# Recall Bulletin 190412REV

Fleetwood Flair Model 32 S only  
Manufactured 6/20/2018 through 2/22/2019

Holiday Rambler Model 32 S only  
Admiral  
Manufactured 6/29/2018 through 3/22/2019

Inspection / Correction of Generator Exhaust Pipe Routing

Figure 1 – Correct Installation

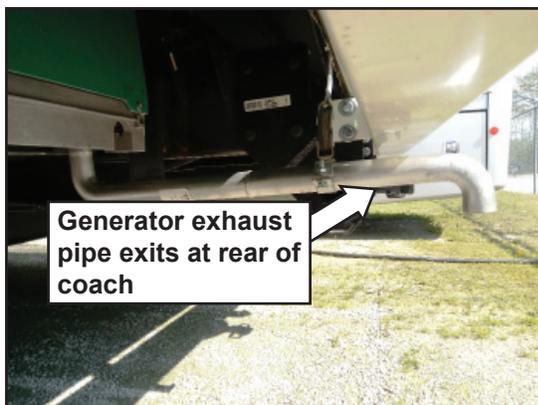
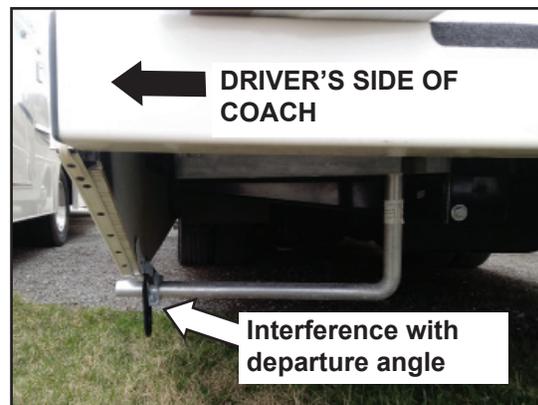
3. Block wheels to prevent movement.
4. At the driver's side, rear of the coach, locate the generator exhaust pipe and determine whether it exits on the side of the motorhome or out the rear, under the bumper. See Figures 1 & 2 for both examples of exhaust pipe routing.

- a) If the generator exhaust pipe exits the motorhome at the rear of the coach under the bumper, take several clear photos (see Photo Requirements on Page 3) and submit a claim using code 6080-11, "Inspected/Not Defective"; no more work is required.

- b) If the generator exhaust pipe exits on the side of the motorhome, take several clear photos (see Photo Requirements on Page 3) and then proceed to the Repair Procedure beginning at Step 5.

Figure 3

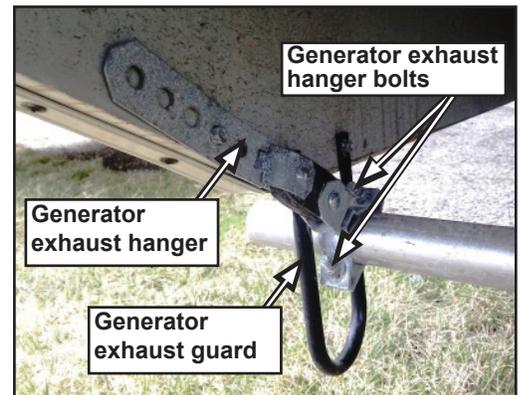
5. Referencing Figure 3:

- Remove the hardware clamping the generator exhaust hanger to the generator exhaust pipe using a ½” open end wrench and ratchet with a ½” deep well socket.
- Once loose from the exhaust pipe, remove the generator exhaust hanger by removing the ¼” HWH screw holding it to the sidewall with a 3/8” driver bit and drill. Set aside all of the generator exhaust hanger components and fasteners for later reinstallation.
- Using a 3/8” driver bit and drill, remove both ¼” HWH screws holding the generator exhaust pipe guard to the sidewall. Discard the generator exhaust pipe guard and mounting screws as they will not be reinstalled.

Figure 4

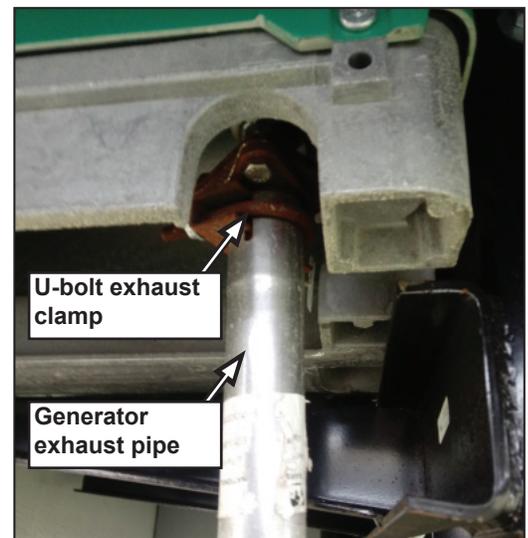
6. Referencing Figure 4, remove the generator exhaust pipe by loosening the U-bolt clamp securing the generator exhaust pipe to the generator with a ratchet and a ½” deep well socket. Set aside the U-bolt exhaust clamp for later reinstallation. Discard the generator exhaust pipe as it will not be reinstalled.

Figure 5

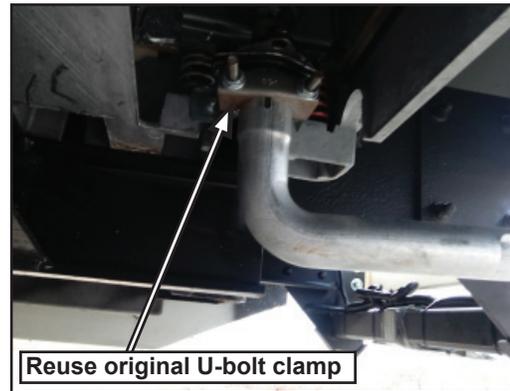
7. Begin reinstallation by sliding the new generator exhaust pipe onto the generator exhaust port until it is fully seated to the bottom of the flared end or is tight against the bottom of the generator. Be sure it is oriented so that it exits the rear of the vehicle under the bumper; reference Figures 5 and 6. Clamp in place with the U-bolt exhaust clamp previously removed in Step 6; carefully position the U-bolt so that the nuts can be easily tightened with a ratchet and a 1/2" deep well socket.

Figure 7

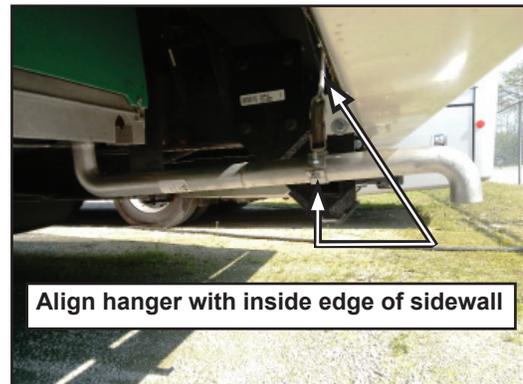
9. Use silicone sealant to seal the screw holes in the sidewall where the defective components were removed, in order to prevent water intrusion.
